PROTERRA

ISSUE DATE:	7/22/2022
SERVICE BULLETIN SUBJECT:	800 Volt Pneumatic Door Pressure Fleet Check
VINs or MODELS AFFECTED:	Service Specified Buses
COMPLETE BY:	Next Service Opportunity
SERVICE BULLETIN #:	SC-22-93
LABOR OPERATION CODE:	WA45Z

800 VOLT PNEUMATIC DOOR PRESSURE FLEET CHECK

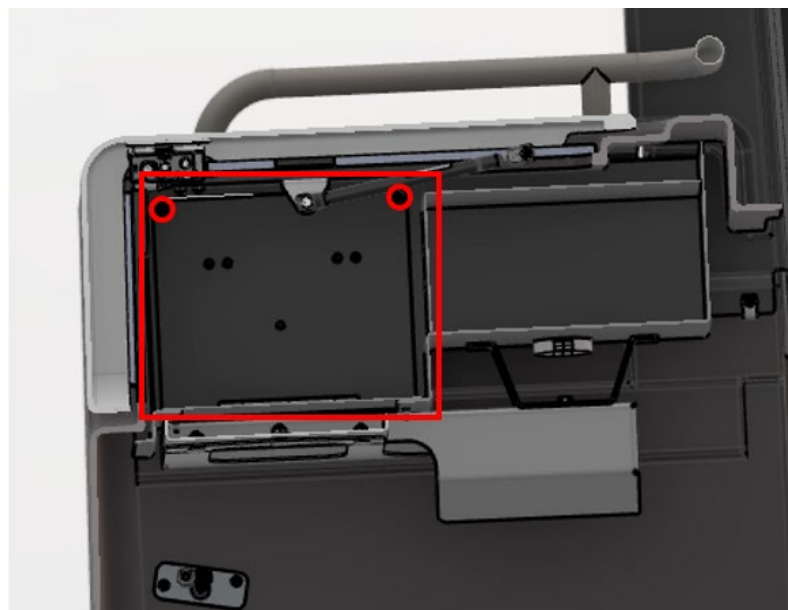
1. Power on the bus and verify that the compressed air system is working by referencing the dash.

2. Open the streetside wheel well box.

3. Using a 10mm Ratchet/Socket, open the hinged panel on the left side of the interior of the wheel well box to expose the pressure regulators.

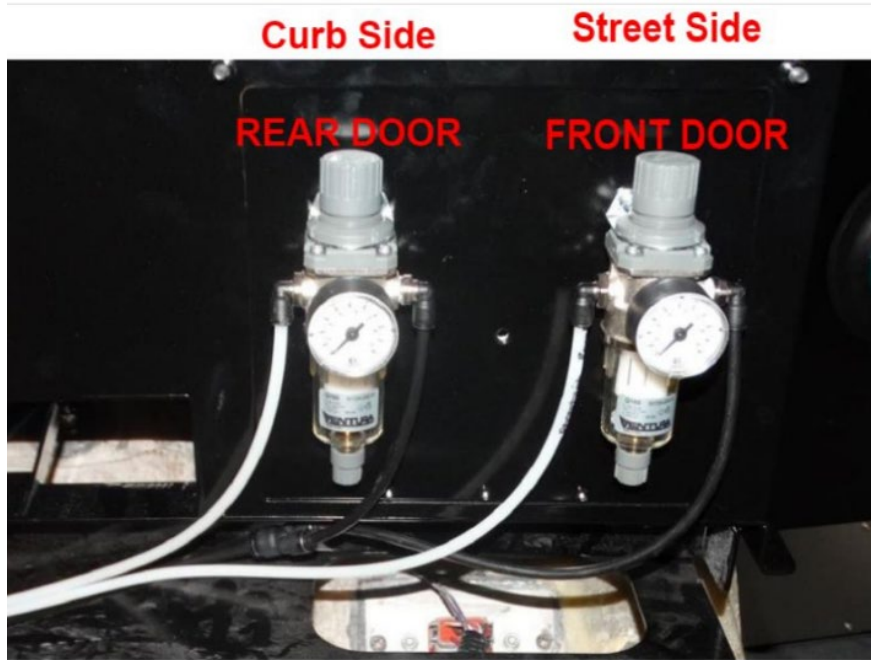
4. Check the adjustment of the pressure regulators. The regulators should be set between eight and nine Bar.

5. If the pressure is found to be set correctly, ensure that the knobs on top of the regulators are pressed down into the locked position.
6. If either pressure regulator is not set correctly, lift the knob, and adjust the pressures to between eight and nine Bar. Ensure that the knobs are down and locked after the adjustment is complete.
7. Using a 10mm Ratchet/Socket, close the hinged panel.
8. Close and latch the streetside wheel well box.
9. Return the bus to service after ensuring proper operation of the doors.
